Our Reference: RC235259/231130192964

RESOURCE CONSENT APPLICATION FOR LAND USE

ENERGY BAY LIMITED - 87 UPPER SEFTON ROAD, SEFTON

Figure 30.4: Sight Distances and Sight Lines for Vehicle Crossings

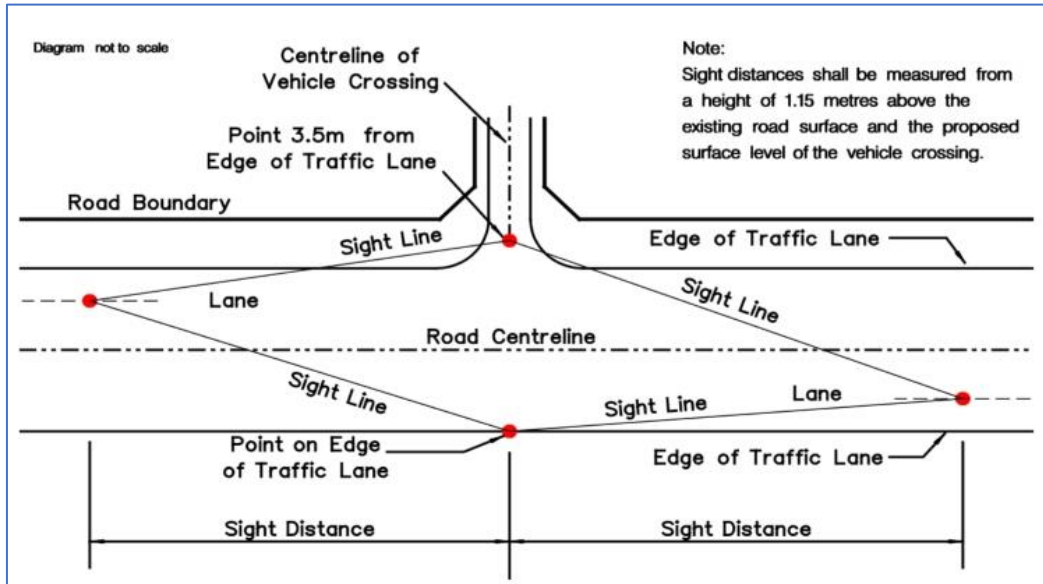
- 6.3 Please confirm if sight distance requirements are met for the proposed access off Beatties Road as required by rule 30.6.1.24 and 30.6.1.25.

The sight distances and sight lines shall be measured as depicted in Figure 30.4. The sight distances shall be measured from a height of 1.15m above:

- a. the existing road surface; and

b. the proposed surface level of the vehicle crossing.
